# **Coffs Harbour Regional Boat Ramp**

Submissions report  
**February 2021**

# Stage 1 (top) and Stage 2 (bottom)—new Plan

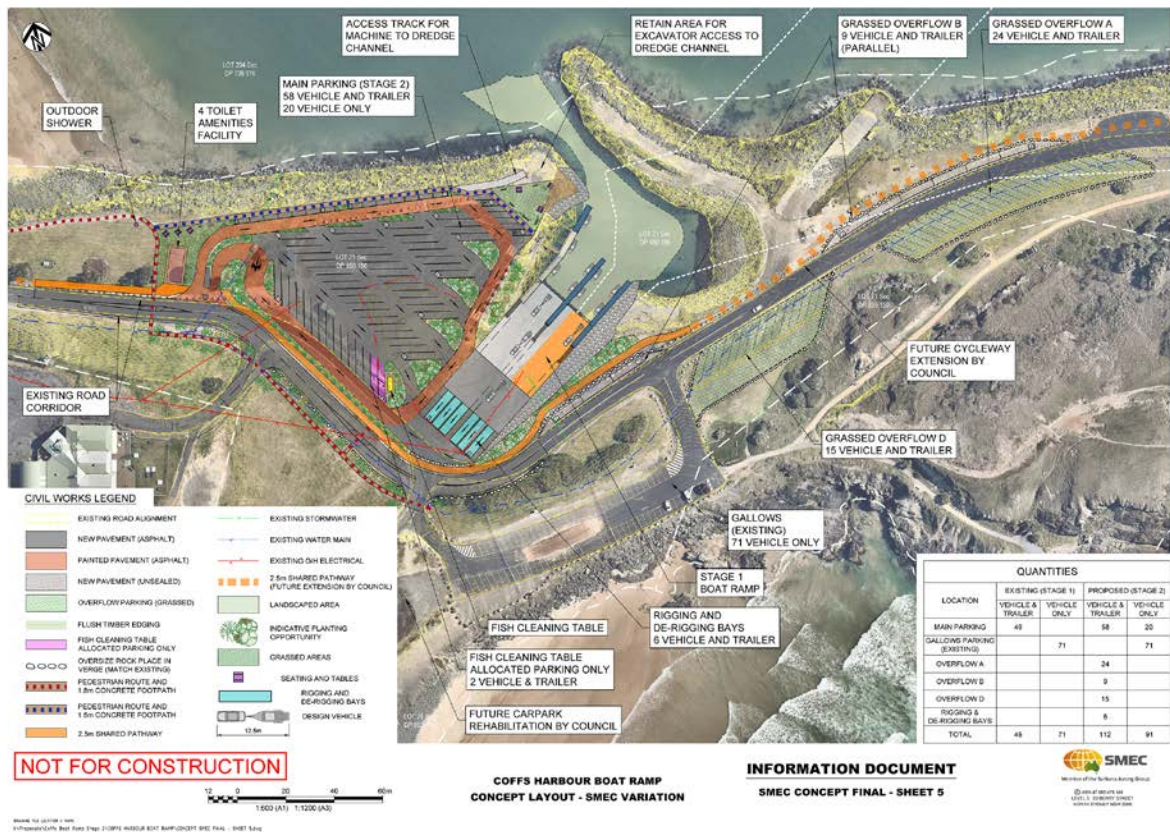
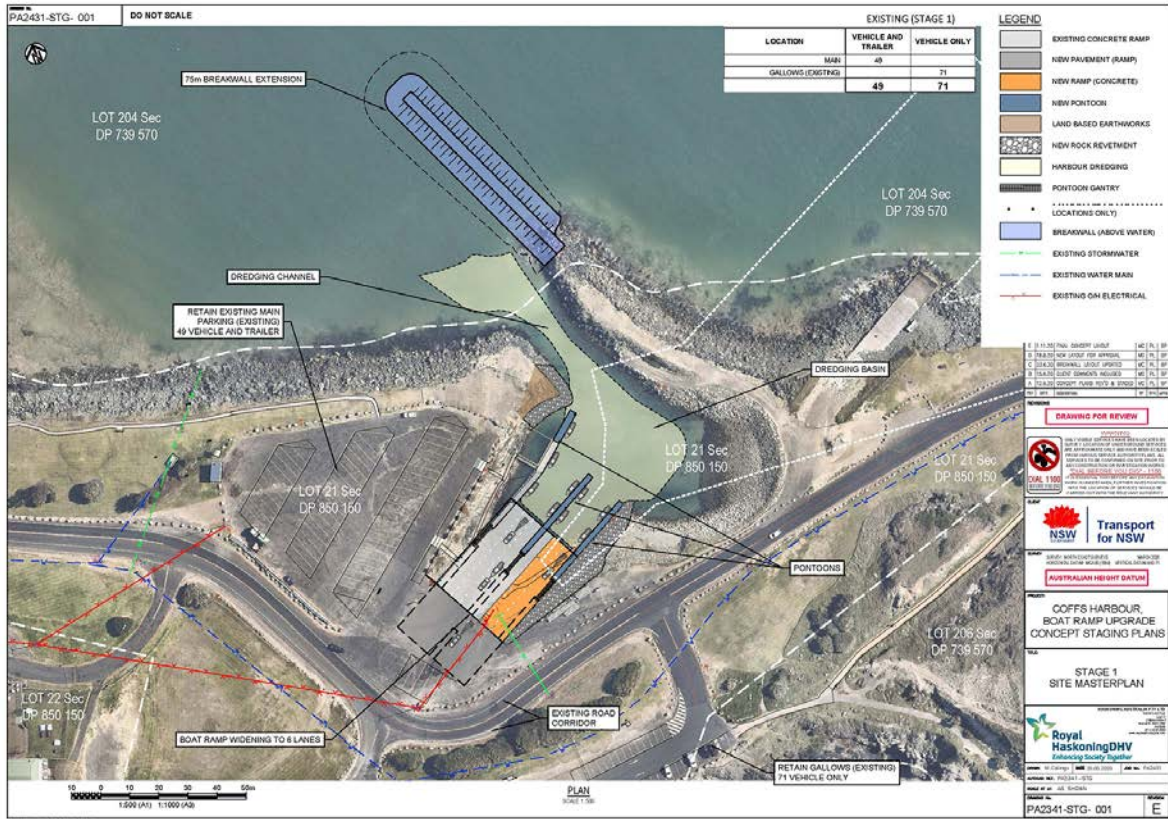
- The access road travelling through the carpark will increase congestion.
- Some roads are very twisting and have tight corners which will be difficult or impossible to negotiate with a trailer.
- Boat rigging areas are in the wrong place...they will interfere with the traffic.
- The plan needs dual access entrance and exit points.
- Traffic will split and merge again on entering the ramp area. This will create congestion.
- Add a lane to Jordan Esplanade to allow trailers to queue there waiting for ramp access..

- All car/trailer parking spaces should be drive-through, rather than requiring vehicles and trailers to drive in and reverse out.
- Plantings in the carpark should be removed, as they obstruct traffic and take unnecessary space
- The parking lot layouts need to be revised. It seems that some are angled against the traffic flow, making it hard to turn into and reverse out of.
- Single car (no trailer) spaces are necessary for boat crews to park, but perhaps these could be removed to the “Overflow Parking” areas, rather than adjacent to the ramp in the main carpark.
- Perhaps relocate the single-car spaces to the Gallows Beach side of the ramp, which will increase the trailer parking in the main carpark.

The concept master Plan for Stage 2 has been updated from that indicated in the REF

- A flow thru carpark (as requested) has been achieved with very minimal loss of parking spaces for car/trailer – achieved with a reduction on landscaping and plantings in centre bays but a good compromise TfNSW has worked with consultants closely on this layout and believes the traffic flow into and out of the carpark is efficient

- Landscaping has been revised and is now included on north and south side of Jordan Esplanade, on north/south end of each parking bays, around the fishing cleaning area and around the entrance to the carpark

- The red pedestrian path has moved to west of amenities block

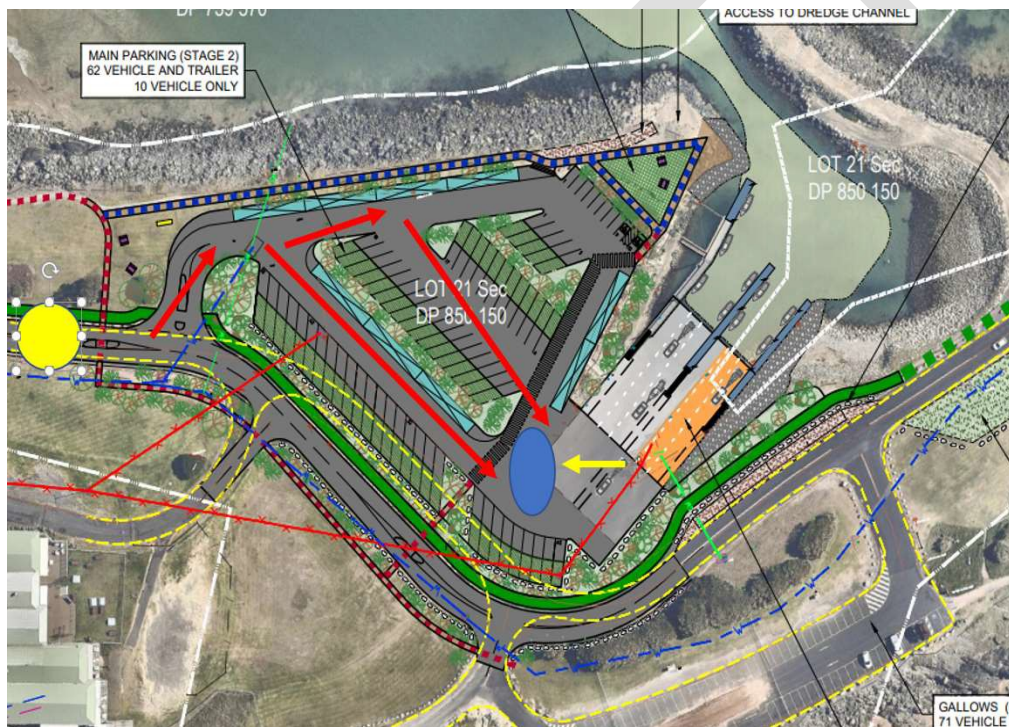
But your plan has a 'funneling effect' that will split and re-group traffic in several area's. It will also make the use of trailer parking unavailable during these times and add to wait times and frustration.

To add further confusion and traffic chaos the trailers leaving the ramp (indicated by the yellow arrow) will also converge on this spot.

In addition, people are going to prep their boats on the pad in front of the ramp which will add more calamity and danger to the situation.

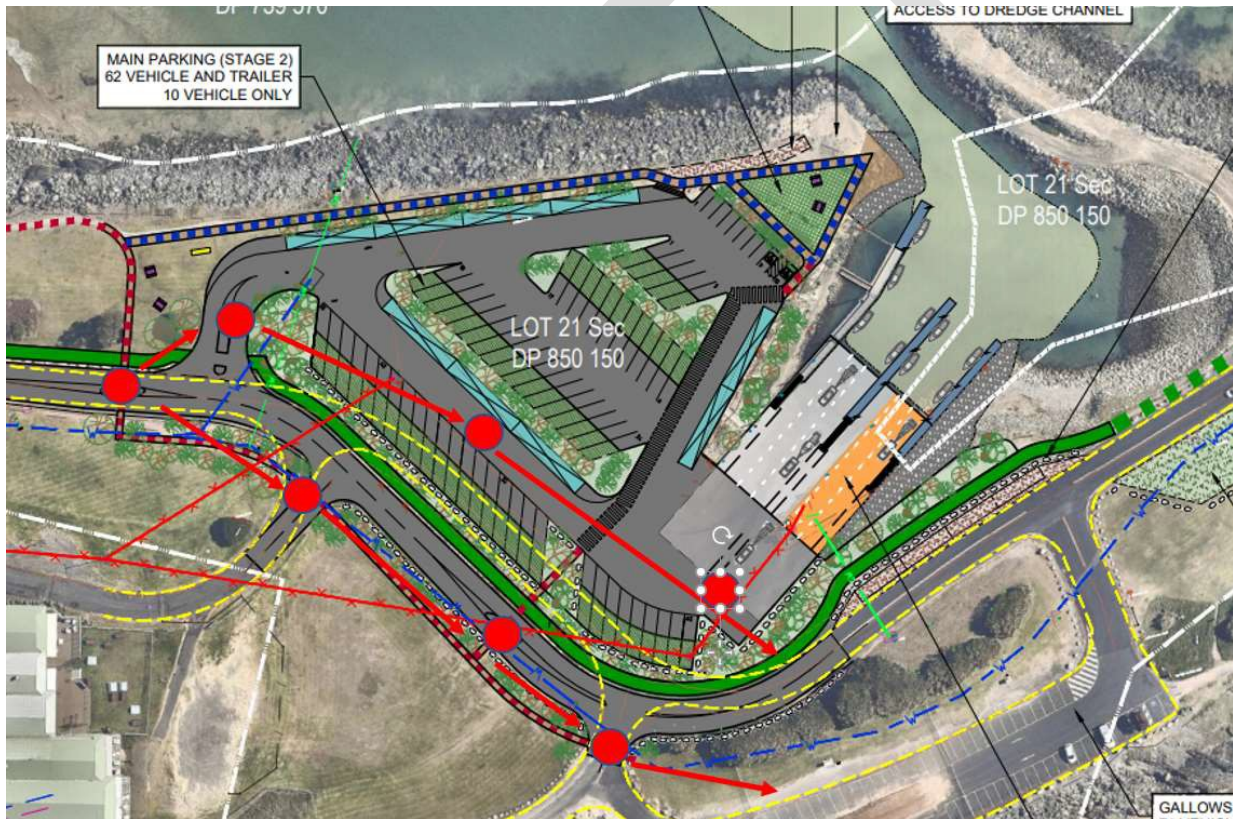
People do not follow signage and I am yet to meet anyone who when walking near the ocean would want to be directed away from it.

Below red arrows show you the path's that a pedestrian will take to get to gallows beach or the south breakwall. Simply put they will cut across the area and into a high (reversing) traffic zone. (We already see this happening today)
